Homestead High School Expansion/Renovation Project
Phase 2B - Gymnasium and Auditorium Additions - General Construction
12.9.20
Addendum No. 2

Questions and Front End Clarifications - Pre-Bid Meeting - CSO Architects Addendum No. 2

ADDENDUM NO: 2

PROJECT: Additions & Renovations to Homestead High School
Phase 2B

5 ENLARGED DETAIL UNIT-B CHOIR RM
A756-2 SCALE: 1 1/2\"/>

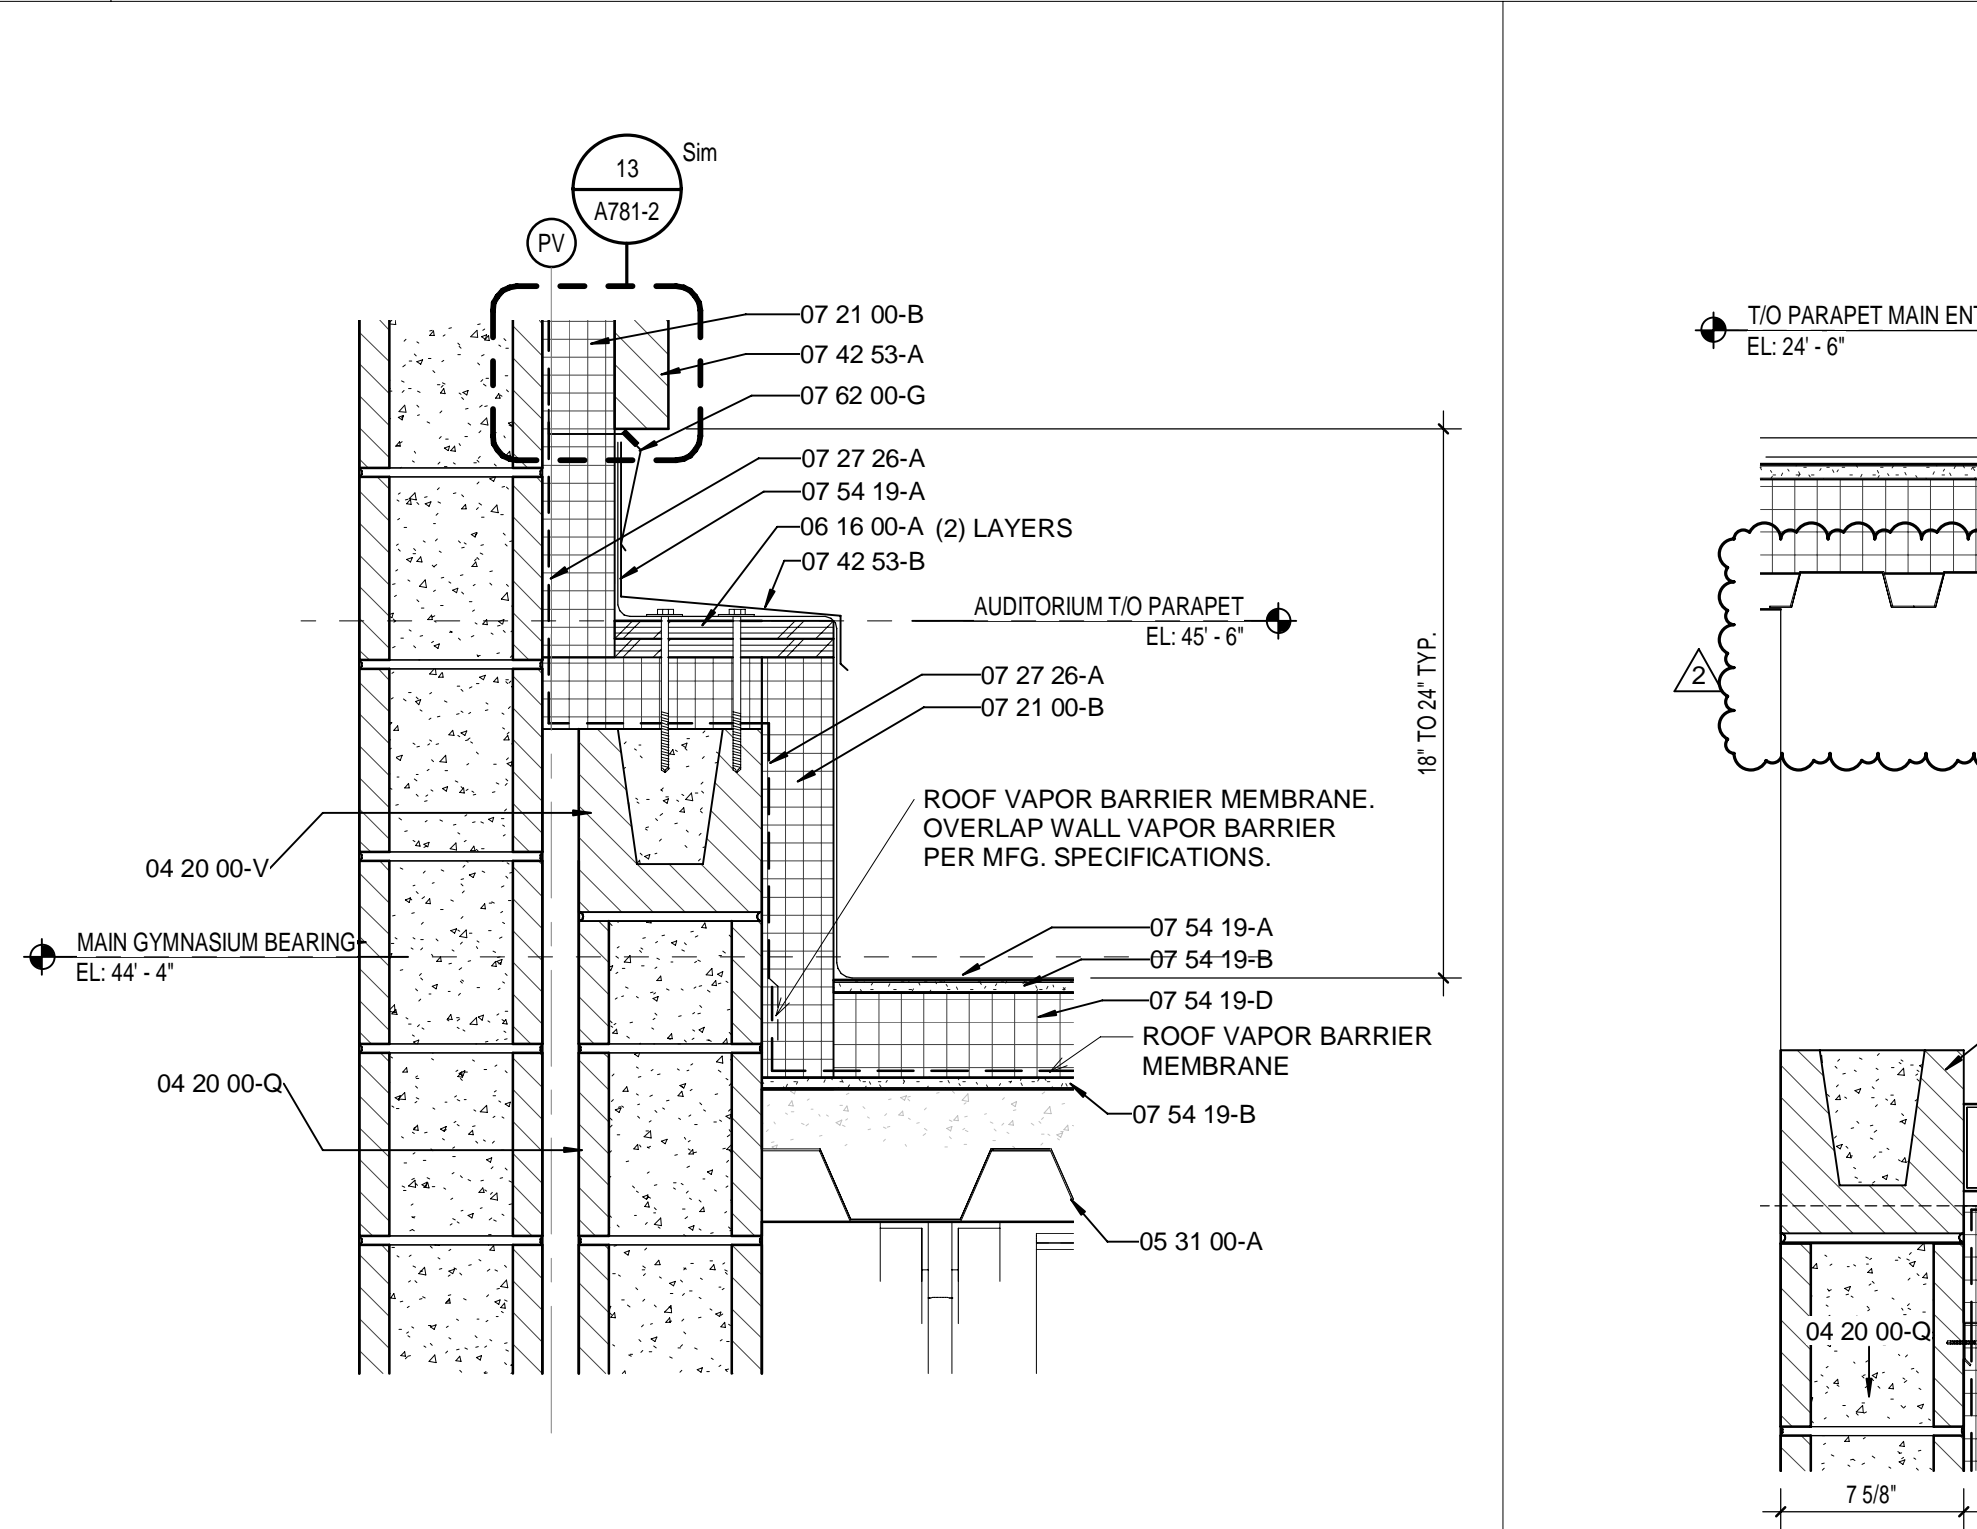
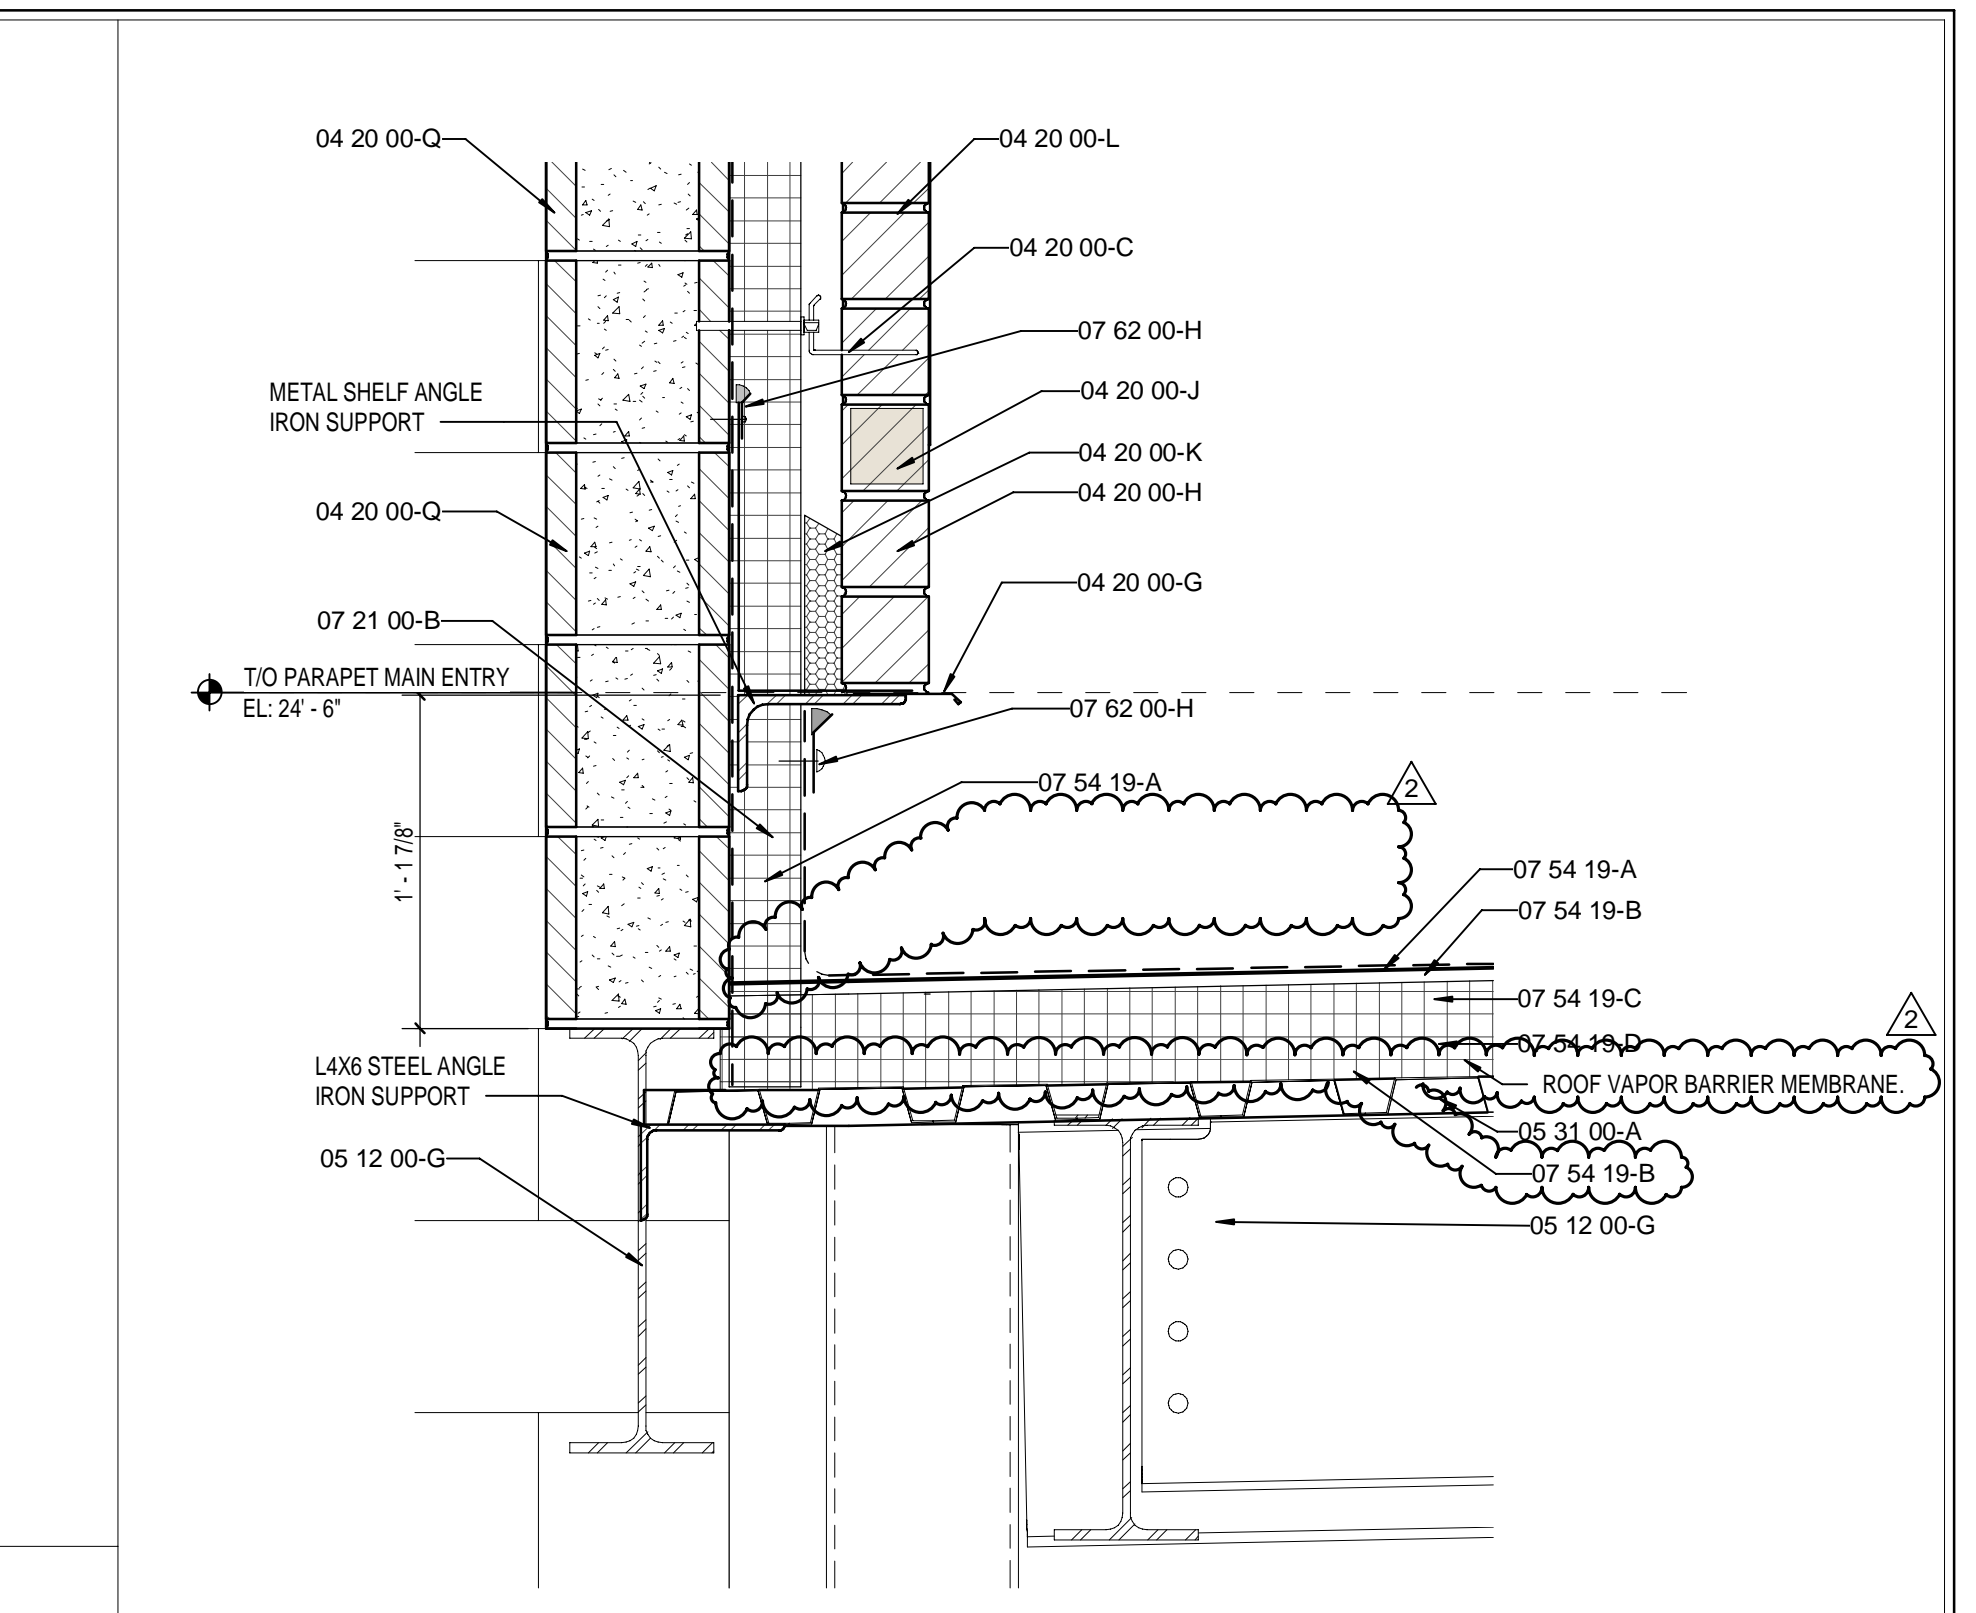
3.012 A756-2 – ENLARGED PLAN DETAILS

- A. Delete roof vapor barrier membrane and ½" gypsum deck board 07 54 19-B at all areas with corrugated metal deck. Note: The only area to receive a roof vapor barrier is at the concrete roof deck at the auditorium.
